**File #: IR-24-023, Version: 1**

## **INFORMATION REQUEST (IR) - BILD Edmonton Metro regarding Bylaw 18/2024**

Requested by: Mayor Heron

Date of Request: October 15, 2024

Figure 1: 20 ft Building Pocket Zero Lot-Line Block Face

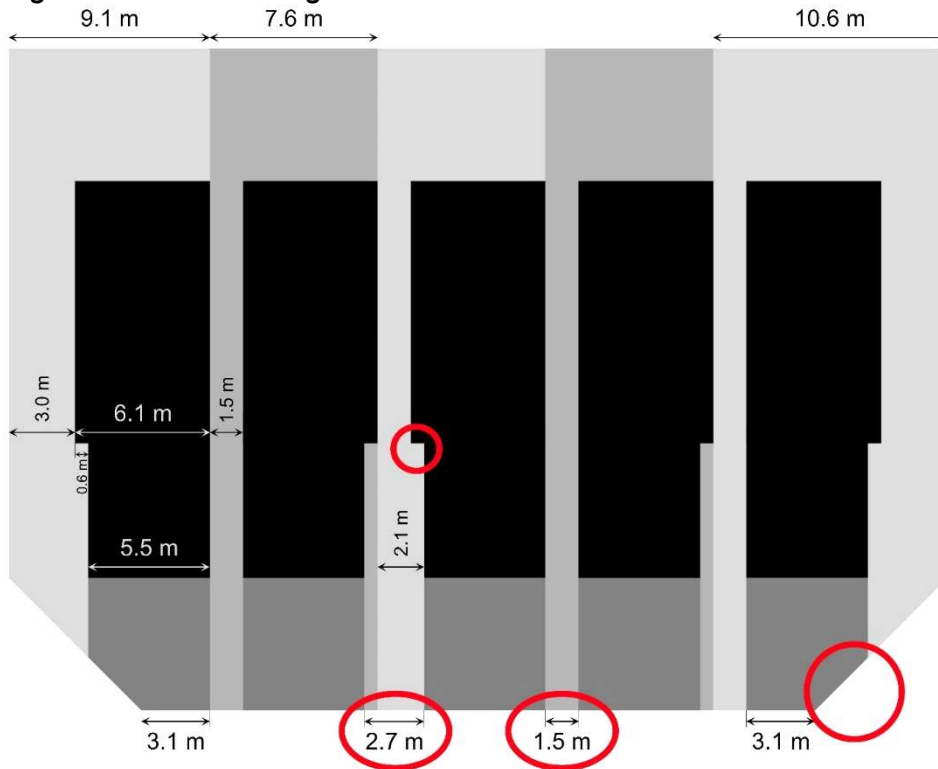
With the 20-foot building pocket, as shown in Figure 1, the difference between the width of the house and the width of the garage is about 0.6 m (2.0 ft) (if building an 18 ft garage). That is not enough width to feature a full front door, which typically requires at least 1.2 m (4.0 ft). As shown on Figure 3, Figure 4, and Figure 5, the front entry on these products will need to be recessed or partially recessed, depending on the size of the garage. Garages and driveways will dominate the front streetscape. The resultant built environment is anticipated to go against the first principle of Crime Prevention Through Environmental Design (CPTED), which is to provide natural surveillance.

As shown on Figure 1, the distance between the driveways is approximately 1.5 m (4.9 ft) or 2.7 m (8.9 ft) for lots with a 6.1 m (20 ft) wide home. As shown on Figure 2, the distance between the driveways is approximately 1.5 m (4.9 ft) or 3.9 m (12.8 ft) for lots with a 6.7 m (22 ft) wide home.

On a corner lot, there would be conflict between the driveway and the corner cut. Typically, our streets have corner cuts, we looked at a standard 6.0 m corner cut on Figure 1 and Figure 2. Corner cuts are used to create a visibility triangle for drivers at intersections. The corner cut would impact the driveway on a corner lot significantly. The homeowner would be left with a 3.1 m (10.2 ft) area to enter and exit their lot, instead of the regular 5.5 m (18.0 ft) of driveway width. The driveway would need to taper significantly, to avoid being placed in the corner cut.

Figure 2: 22 ft Building Pocket Zero Lot-Line Block Face

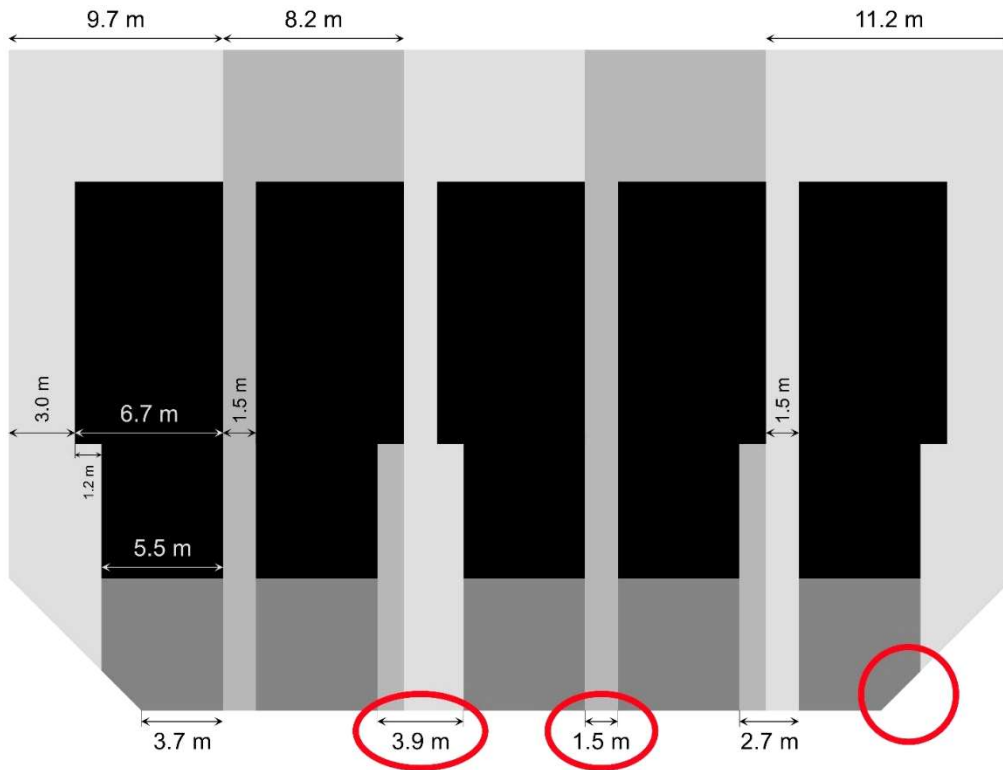
Please note, with the 22.0 ft building pocket, there will be room to feature a full front door (if a 5.5 m [18.0 ft] wide garage is constructed).

*Figure 7: 3.7 m (12.1 ft) Wide Townhouse at 55% Lot Coverage*

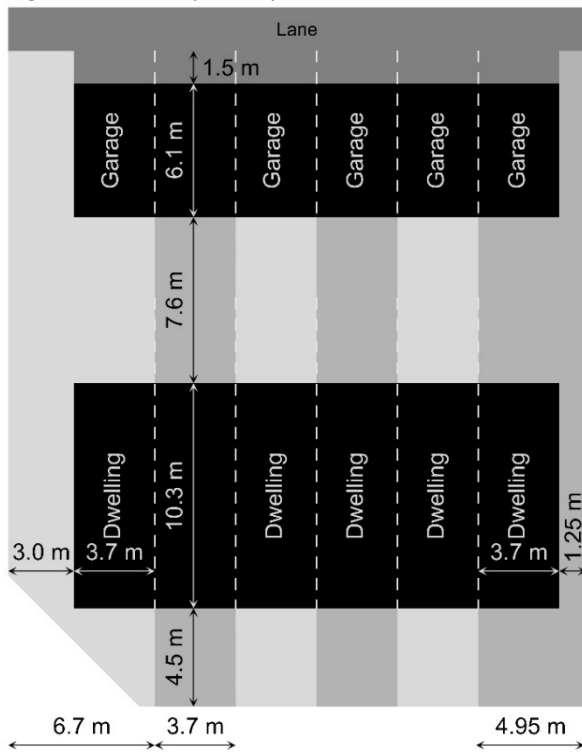
- A 3.7 m (12.1 ft) wide unit would be approximately 67 sq m (720 sq ft), if constructed as a two storey dwelling, as shown in Figure 7. This does not meet our minimum dwelling size requirement of 75 sq m (807 sq ft) in the LLR District, as per LUB 9/2005 section 5.4(8)(a).
- A 4.3 m (14.1 ft) wide unit would be approximately 79 sq m (850 sq ft), as shown in Figure 8.

- 2.8 m (9.2 ft) of home width for some portions of the 3.7 m (12.1 ft) wide townhouse unit, and
- 3.4 m (11.2 ft) of home width for some portions of the 4.3 m (14.1 ft) wide townhouse unit.

Figure 11: 5.5 m (18.0 ft) Proposed Garage Dimensions

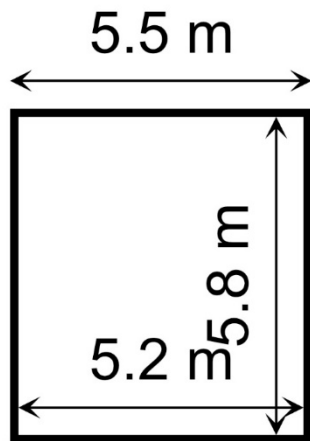
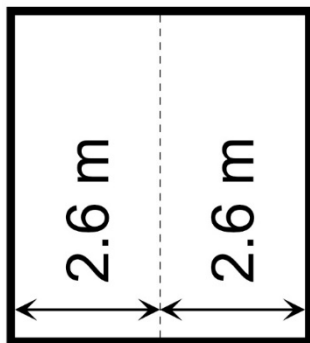
An unobstructed perpendicular parking stall currently requires a minimum dimension of 2.6 m (8.5 ft) by 5.8 m (19.0 ft). In this case, the intent was the stall would be unencumbered, and not have any obstructions that would block the door swing of the vehicle. This would be the dimension seen in a typical surface parking lot. In these cases, the door would swing over the yellow painted line demarcating the stall, as shown in Figure 13.

The requested garage, as shown in Figure 12, only has 2.6 m (8.5 ft) of width per vehicle. The addition of walls adds a limitation to how effectively this distance can function, as there is less room per vehicle.

*Figure 14: Two Vehicles in an 18-foot-wide Garage*

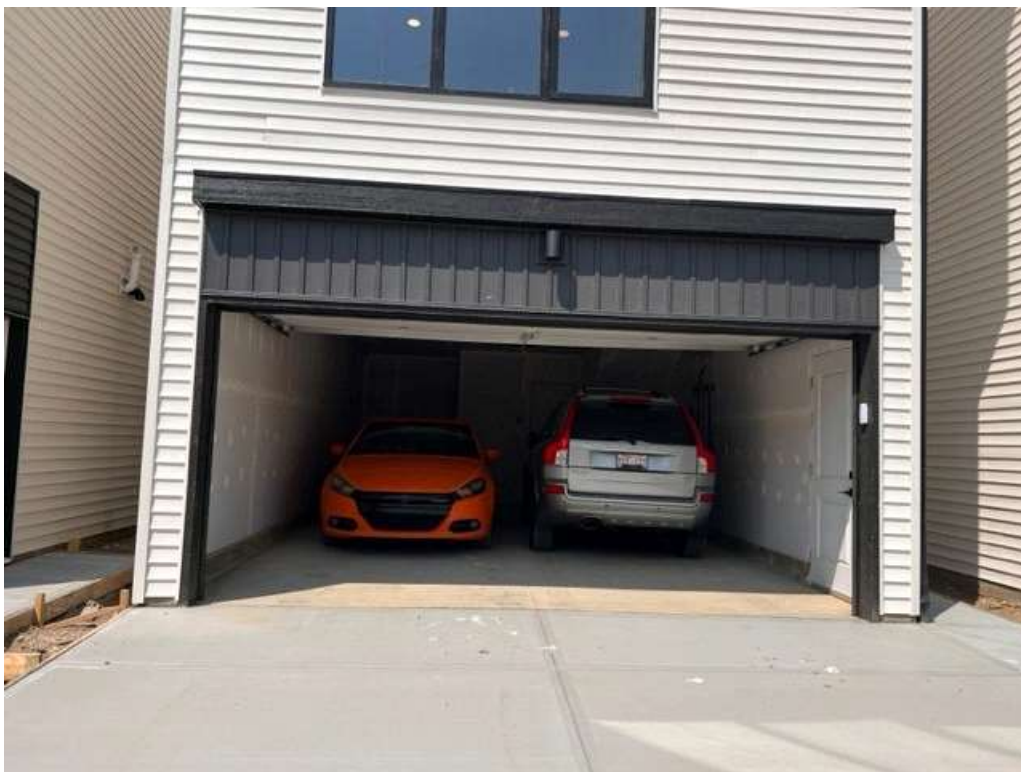
There are pictures showing two vehicles parked in a 5.5 m (18.0 ft) wide garage, see Figure 14. Administration observed the scenario in Figure 14 and noted:

1. The narrower garage configuration generally requires one car to back in, and one car to pull in to allow communal space to enter and exit the vehicles.

2. The sideview mirrors cause an obstruction to entering and exiting the garage, as they protrude from the vehicle, and in some cases, can't be folded in.

3. New vehicle sales in Alberta are primarily comprised of mid-sized SUVs or pickup trucks (at rates of 70% or greater of new vehicle sales). With St. Albert having more vehicles per capita than the Alberta average, there is concern that the scenario illustrated in Figure 14 would not work with two mid-sized SUVs.

Figure 16: Turning Bay on Riel Drive

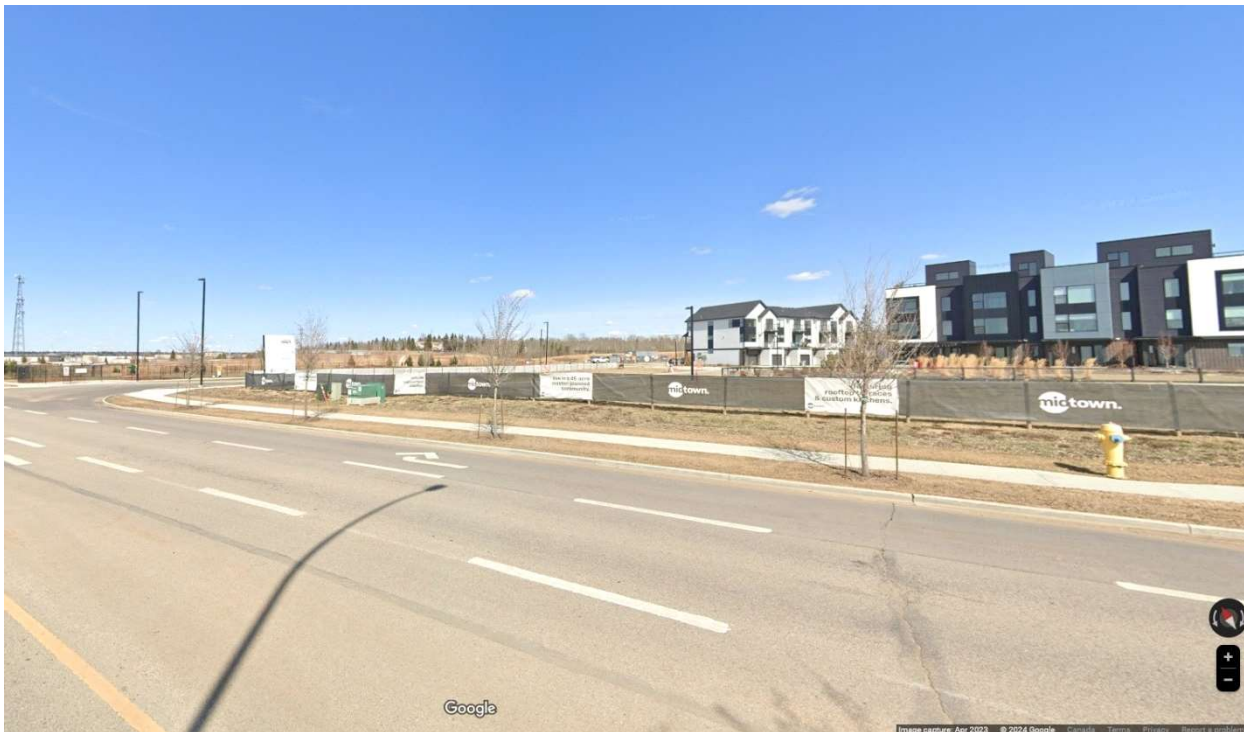
On the city owned streets that flank the Midtown neighborhood, there is a lack of on-street parking. Riel Drive does not allow on-street parking in this area, because there is a turning bay to get into the Midtown development, as shown on Figure 16. Further north along Riel Drive there are two bus stops, and two fire hydrants (as the road approaches the intersection with Levesseur) that would prevent on-street parking. There is also another intersection with a future road that will be constructed, and there won't be on-street parking in that area as well.
